SUBDIVISION COMMITTEE
METROPOLITAN AREA PLANNING COMMISSION

STAFF REPORT
(Final Plat)

CASE NUMBER: S/D 91-58 - DODDS ADDITION

LOCATION: At the southwest corner of 45th Street North
and Ridge Road.

VICINITY MAP:

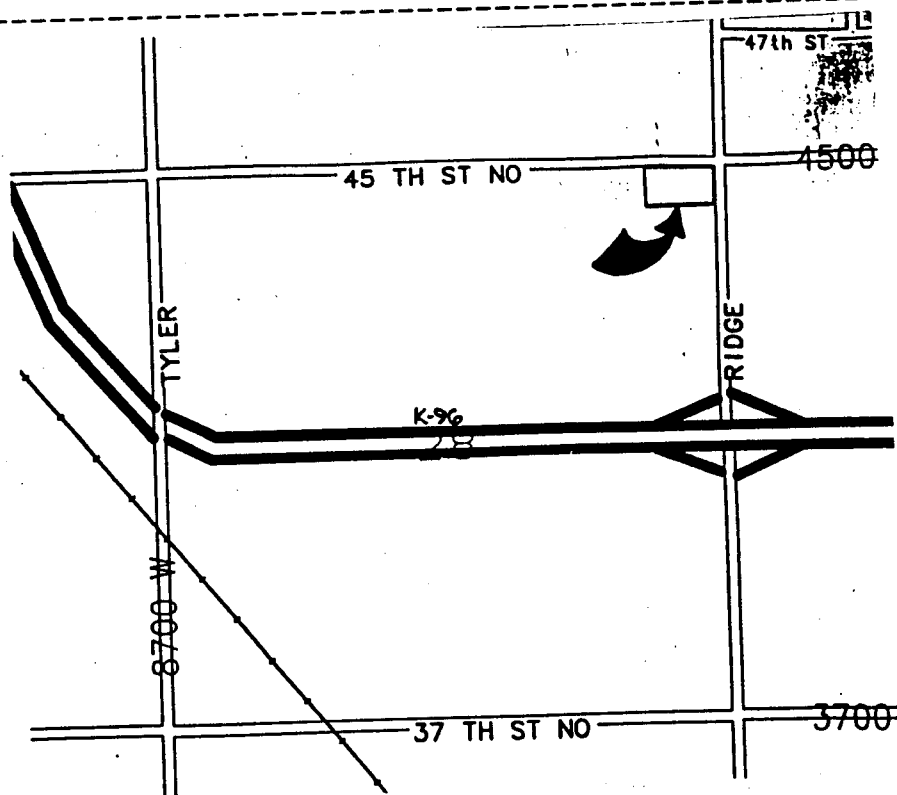
- D. On the final plat tracing, the complete access control for lot 1 shall be shown from a distance of 100 feet from the northeast corner of this lot along both 45th St. North and Ridge Road, rather than from the center of the intersection.

- E. Although the building setback along the north line of this plat appears to be a requirement of the pipeline, in order to also assure that a building setback will be observed in the future should the pipeline ever be removed, the final plat tracing shall show this setback as "platted and pipeline building setback."

- F. For the existing structure located on lot 1 and within the contingent street dedication and 25-foot building setback, the applicant is advised that the portions of the building within these areas may be maintained or remodeled but the building within those areas cannot, however, be enlarged and if the building is removed, any new building construction must observe the platted building setback.

- H. Any relocation, lowering or encasement of the pipeline, made necessary by this development, will not be at the expense of the City.
- I. The applicant's agent is advised that the recording information for the pipeline easement appears to have an error on the "Misc. Bk number". The proper number shall be indicated on the final plat tracing.
